UNITED STATES PATENT AND TRADEMARK OFFICE

APPLICATION NO.	FILING DATE	FIRST NAMED INVENTOR	ATTORNEY DOCKET NO.	CONFIRMATION NO.
10/551,624	06/26/2006	Stephane Moreau	17102/023001	5504

Office Action Summary	Application No. 10/551,624	Applicant(s) MOREAU ET AL.	
	Examiner ALEXANDER B. COMLEY	Art Unit 3746

DETAILED ACTION

FIG. 3

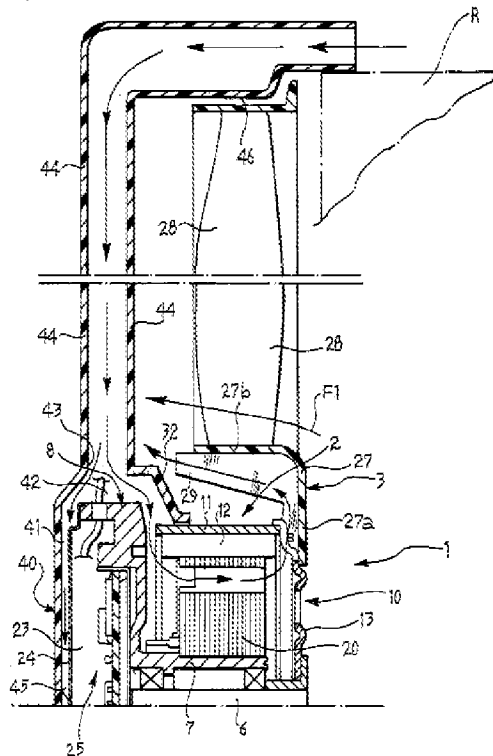
In regards to Independent **Claim 1**, and with particular reference to Figure 3 shown immediately above, Avidano discloses:

(1) A ventilation device (1) comprising a fan (3) capable of being driven rotationally by an open electric motor (2) which is firmly attached to a support (40, 44) intended for fixing said ventilation device, the fan consisting of a plurality of blades (28) which are distributed regularly around a bowl (27) inside which there are arranged internal ribs (29) capable of ventilating said open electric motor, characterized in that the support comprises a central part (32) which is connected in a substantially sealed manner to at least one peripheral portion (11) of the open electric motor.

As shown in Figure 3 above, Avidano et al. discloses an electric motor-driven fan unit for use in motor vehicles. Avidano's fan is designed with a hub and airflow structure that allows the fan's internal blades to cool the motor. In particular, Avidano states "A motor-driven fan includes an electric motor including a rotor and a stator in which the rotor includes an essentially cup-shaped cap which extends at least partly around the stator and has a plurality of lateral exit openings adjacent the bottom wall, and an impeller or fan including a hollow hub from which extends a plurality of main outer fan blades. This hub has a front wall fixed to the back wall of the cap of the rotor and a lateral skirt which surrounds the lateral wall of the cap in a radially spaced relationship. The hub is further provided with inner ventilation blades acting in operation to generate a cooling air stream which passes through the motor." (Abstract) Moreover, Avidano specifically describes the hub structure of Applicant's claimed invention by stating "The fan or rotor 3 of the motor-driven fan comprises a hollow hub 27 (FIG. 1) from which extends a plurality of main outer fan blades 28. The hub 27 has a front wall 27a fixed to the radial projections 15 of the disc element 13 of the cap 10, by means of rivets 29 or the like (FIG. 1). The hub 27 of the fan 3 further has a lateral, essentially cylindrical, skirt 27b which surrounds the side wall or ring 11 of the cap 10 in a radially spaced relation thereto. As is seen in FIG. 1, the hub 27 of the fan 3 is further provided, in the space 30 defined between the ring 11 of the cap 10 and the skirt 27b of the hub of the fan with internal fan blades 29 which extend in respective inclined planes with respect to the radial direction." (Column 2, Lines 36-48) Avidano discloses a main

support body (40, 44) that is composed of rear body 40 and aspiration duct 44. These two structures make up a rear-end support that helps to support the motor 2 within central support 32. As shown in Figure 3, central support 32 is substantially sealed to the outer periphery 11 of the motor 2, thereby helping to seal the motor within the support. In particular, Avidano states "In the embodiment of FIG. 3 a rear body 40 is fixed to the stator body 8 on the side opposite the fan 3, which extends in facing and spaced relationship with respect to the cover 24 and which surrounds the periphery of the stator body 8 lying close the annular separator element 32." (Column 3, Lines 42-45) Avidano goes on to disclose a physical connection between the element 32 and the motor stator by stating, "Conveniently, although not necessarily, the motor-driven fan 1 further includes a separator ring 32 (FIG. 1) of essentially conical form, disposed around the end of the cylindrical wall 11 of the cap 10 facing the stator body 8 as well as around the ends of the cooling fins 26 of this stator body facing the fan. The separator ring 32 the function of which will be described hereinafter, can be fixed to the stator body 8 in various known ways." (Col. 2, Lines 54-61) And finally, Avidano describes a substantial sealing function provided by the element 32 in stating "This air stream discharges out by passing between the rear edge of the skirt 27b of the hub 27 of the fan and the annular separator element 32. This latter acts to impede mixing of the air stream entering the electric motor 4 with the air stream leaving it, as well as impeding the ingress of extraneous bodies or atmospheric agents into the electric motor." (Col. 3, Lines 17-24) Clearly from this disclosure, support 32 is substantially sealed to the motor since it acts to precisely control the airflow paths to prevent mixing thereof, as

well as prevent ingress of harmful substances to the motor. Therefore, the annular separator 32 is substantially sealed to the periphery of the motor.

6. In regards to dependent **Claims 2-5 & 15**, the annular separator element 32 surrounds and holds the outer periphery of the motor element 2. Moreover, it can be seen in Figure 3 that the inner edge of separator element 32 cooperates with the annular wall of the motor in a continuous, contiguous fashion, while the cover 24 cooperates with the rear portion of the motor. In particular, Avidano states “The portion of the rear body 40 facing the cover 24 of the stator is conveniently provided with at least one projection 45 in contact with this cover for the purpose of reducing or cancelling the effects of vibration.” (Column 3, Lines 52-55) In regards to dependent **Claims 6-10**, it can be seen in Figure 3 that a blind hole, which surrounds and holds the rear portion of the electric motor, is formed between the annular separator element 32 and the cover 24. This opening (or hole) is attached to the rear part of the motor by tight fitting, and forms a plate around the rear portion of the motor. Regarding dependent **Claims 11-14**, the annular separator element 32 forms a surface opposite the bottom of the hub (i.e. bowl) that directs airflow from the inside of the hub to the outside of the hub (See Figure 3). Moreover, the separator has a concave shape (a quarter of a circle) that is flat, extends discontinuously (as its contour changes), and extends substantially linearly at a portion thereof. Finally, in regards to dependent **Claims 16-18**, Avidano’s fan contains a peripheral part 44 that forms a frame with the central part. Moreover, Avidano’s fan is for use in both an engine cooling device, as

8. In regards to Applicant's argument that central element 32 is not a central part of support 40, the Examiner must respectfully disagree. As shown in Figure 3 above, the entire support structure is composed of rear body 40, aspiration duct 44, and central ring 32. These structures are formed as a single, integral piece, which is indicated by the crosshatching in the figure. With reference to Figure 4, Avidano shows that rear body 40 is fixed (i.e. supports) the stator body 8, which is a primary structure of the motor 2. Avidano discloses this supporting function of the body 40 by stating "In the embodiment of FIG. 3 a rear body 40 is fixed to the stator body 8 on the side opposite the fan 3, which extends in facing and spaced relationship with respect to the cover 24

9. In regards to Applicant’s argument that the ring 32 is not substantially sealed to the motor, the Examiner must respectfully disagree. As stated above, central support 32 is substantially sealed to the outer periphery 11 of the motor 2, thereby helping to seal the motor within the support. Avidano discloses a physical connection between the element 32 and the motor stator by stating, “Conveniently, although not necessarily, the motor-driven fan 1 further includes a separator ring 32 (FIG. 1) of essentially conical form, disposed around the end of the cylindrical wall 11 of the cap 10 facing the stator body 8 as well as around the ends of the cooling fins 26 of this stator body facing the fan. The separator ring 32 the function of which will be described hereinafter, can be fixed to the stator body 8 in various known ways.” (Col. 2, Lines 54-61) Most importantly, however, is Avidano’s disclosure describing a substantial sealing function

provided by the element 32. In particular, Avidano states "This air stream discharges out by passing between the rear edge of the skirt 27b of the hub 27 of the fan and the annular separator element 32. This latter acts to impede mixing of the air stream entering the electric motor 4 with the air stream leaving it, as well as impeding the ingress of extraneous bodies or atmospheric agents into the electric motor." (Col. 3, Lines 17-24) From this disclosure, it is apparent that support 32 is substantially sealed to the motor since it acts to precisely control the airflow paths (and prevent mixing thereof), as well as prevent ingress of harmful substances to the motor. Therefore, the annular separator 32 is substantially sealed to the periphery of the motor.
